Addendum 45 – UN Regulation No. 46

Revision 6 - Amendment 8

05 series of amendments – Date of entry into force: 8 October 2022

Uniform provisions concerning the approval of devices for indirect vision and of motor vehicles with regard to the installation of these devices

Figure 1
Example for the measurement by maximum variation

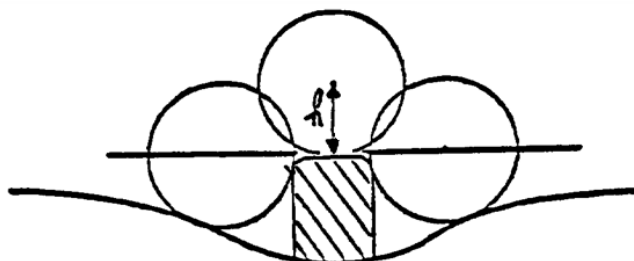
Insert a new paragraph 6.2.2.1.2.2., to read:

"6.2.2.1.2.2. If the dimension of the projection of a component which is mounted on a surface other than convex cannot be determined by simple measurement, it shall be determined by the maximum variation of the distance of the centre of a 100 mm diameter sphere from the nominal line of the panel when the sphere is moved over and is in constant contact with that component. Figure 1 shows an example of the use of this procedure."

Arrangement of approval mark of a device for indirect vision

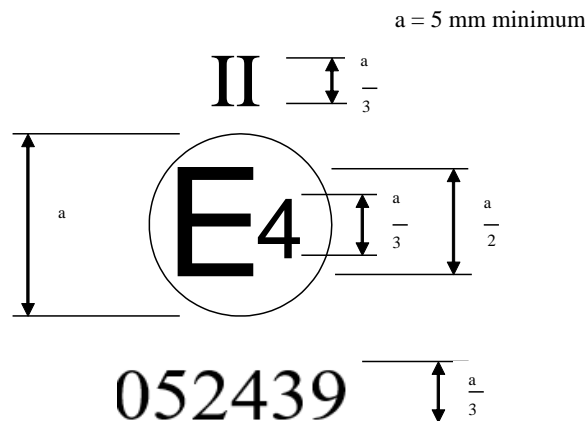
Annex 5; amend to read:

The above approval mark affixed to a device for indirect vision indicates that the device is a main rear-view device, of Class II, which has been approved in the Netherlands (E 4) pursuant

to Regulation No. 46 and under approval number 052439. The first two digits of the approval number indicate that Regulation No. 46 already included the 05 series of amendments when the approval was granted.
